**Item 5.****Development Application: 7 Rennie Street, Redfern - D/2024/69**

File No.: D/2024/69

**Summary**

Figure 19: Shadow diagrams

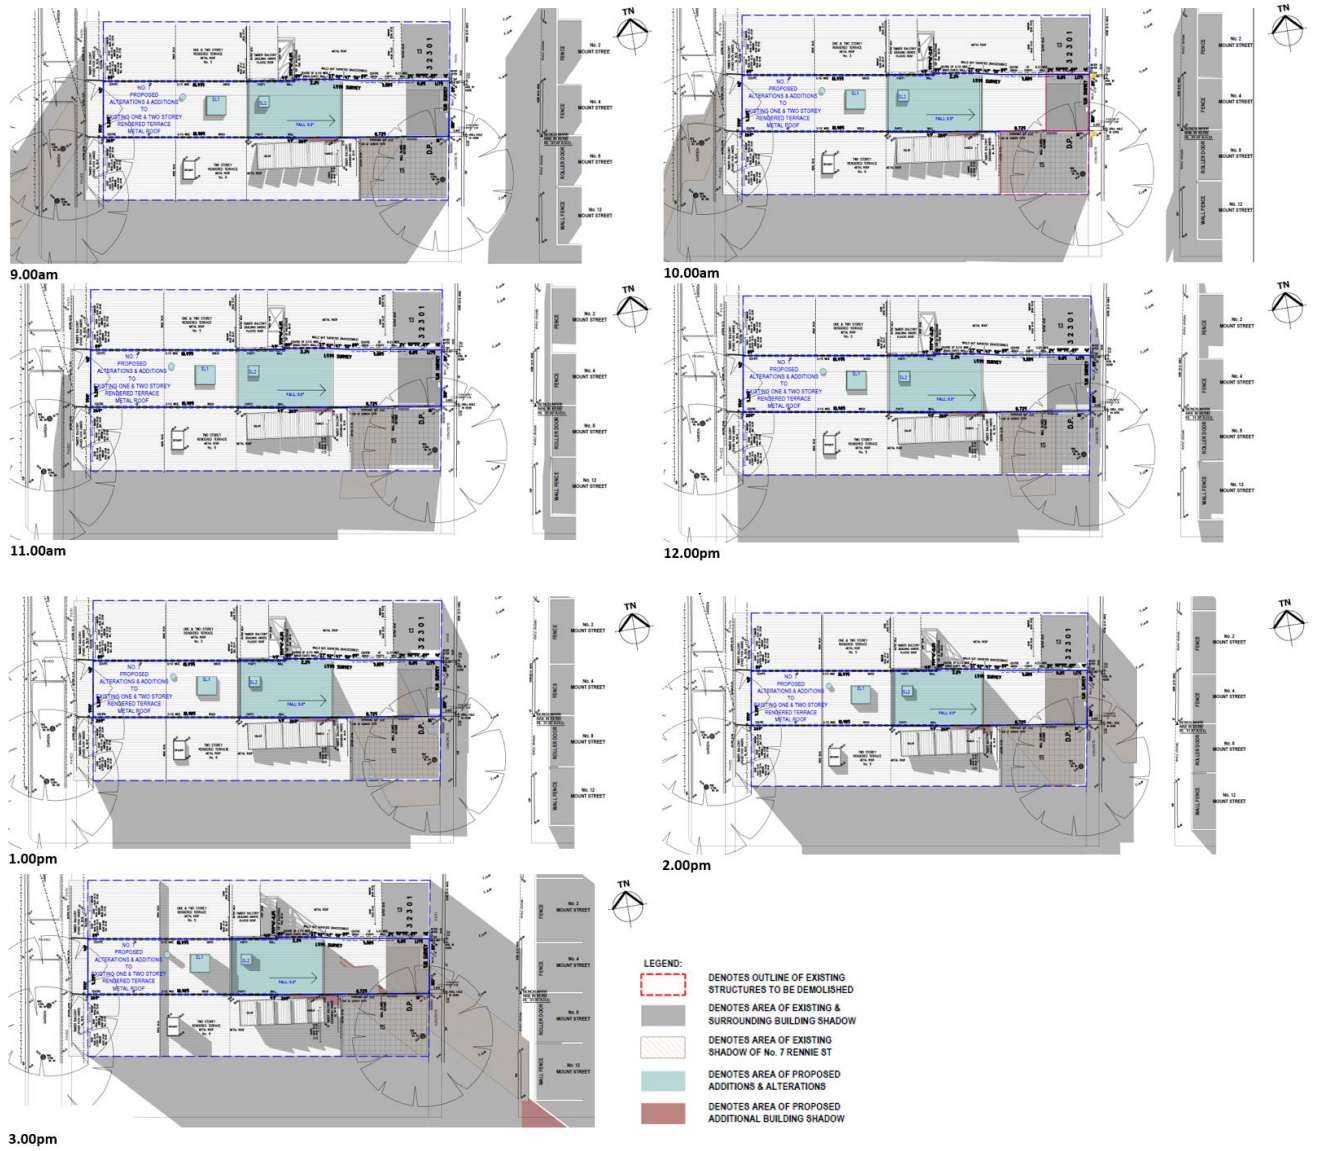
25. The overshadowing impact resulting from the first-floor addition is shown in the accompanying hourly shadow diagrams, reproduced below at Figure 19. The diagrams identify the existing shadows created by the existing surrounding buildings hatched in grey, existing shadows of the subject site diagonally shaded, and additional overshadowing caused by the new first floor addition hatched in red.

26. The existing rear private open space area of the subject dwelling and neighbouring dwellings, in particular terraces located to the south and south-east of the site (Nos. 9 and 11 Rennie Street, 10 and 12 Mount Street) do not currently receive the minimum required sunlight. The extent of existing overshadowing on the site and neighbouring lots are predominately caused by the existing dividing fence, existing ground floor alignment, narrow lot width and site orientation.

27. The shadow diagrams demonstrate:

- (a) The additional overshadowing caused by the proposal predominantly falls on the roof of the adjoining terrace to the south.
- (b) The proposal does not result in any additional overshadowing impacts to the private open space or living room windows of the subject site or neighbouring properties to the south. The proposal is in keeping with Section 4.1.3.1(2) of Sydney DCP 2012.

- (c) The proposal will maintain the existing hour of direct sunlight obtained to approximately 8sqm of the private open space of No. 9 Rennie Street between 11.00am to 12.00pm.
28. The proposed overshadowing impacts are negligible and do not affect the existing level of solar access achieved by neighbouring dwellings or subject site. As discussed under Section 3.1.3.2 of Sydney DCP 2012 above, the minor overshadowing impacts to the roof of No.9 Rennie Street is acceptable given the compact nature of the terrace row, narrow width of the site, compliant building height and rear alignment of the addition that is commensurate with the development pattern of neighbouring properties.

**Figure 20:** Sun eye diagrams, new addition hatched in blue

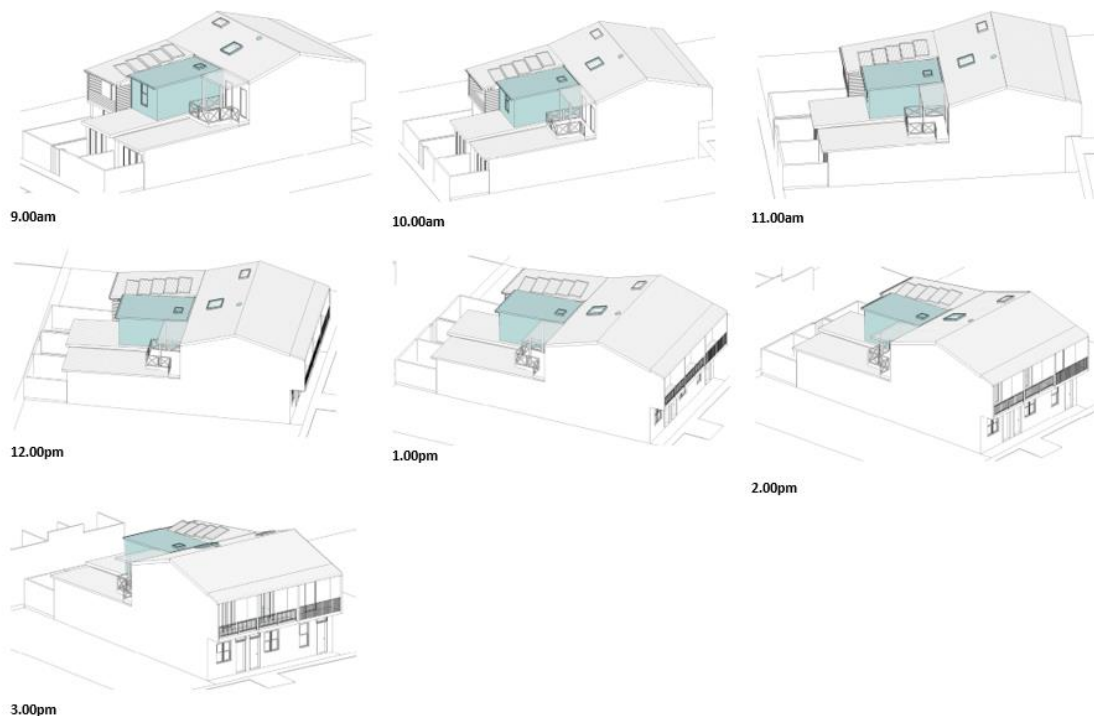
44. The application was discussed with Council's Construction and Building Unit, Heritage and Urban Design Unit, Public Domain Unit, and Tree Management Unit.
45. The above units advised that the proposal is acceptable subject to conditions. Where appropriate, these conditions are included in the Notice of Determination as discussed elsewhere in this report.
46. It is noted that Council's Heritage and Urban Design Unit raised initial concerns regarding the amenity of the new study (originally proposed as a bedroom) given its reliance on an operable skylight in lieu of the creation of a lightwell with a window to accommodate light and air.

47. The objectives of Section 4.1.3 of Sydney DCP 2012 require dwellings to be designed to ensure enhanced residential amenity for the occupants with adequate solar access and ventilation. Section 4.1.3.4(4) stipulates developments to address solar access by optimising orientation and placement of windows and habitable rooms, as well as providing skylights or clerestory windows to improve solar access and provide shared light to poorly lit parts of a dwelling.

48. The proposed reliance on the skylight for amenity to the room is considered acceptable in this instance for the following reasons:
- The sun eye diagrams (refer to Figure 20) demonstrate that the proposed operable skylight to the study optimises solar access achieved to the room, when compared to a window in a light well. The new skylight receives six hours of sunlight in comparison to a window in a light well which would receive less than two hours of sunlight due to the orientation of the site and narrow lot width (of 3.19m). The proposal optimises solar access through the placement of the opening in response to Section 4.1.3.1(4) of Sydney DCP 2012;

- The proposal complements and mirrors the layout of the southern adjoining dwelling at No. 9 Rennie Street (approved under D/2009/798);
  - Confirmation from Lorus Building Approvals and Certification the skylight will provide sufficient natural light and ventilation to the study and complies with the deemed to satisfy provisions of Sections 3.8.4 and 3.8.5 of the NCC;
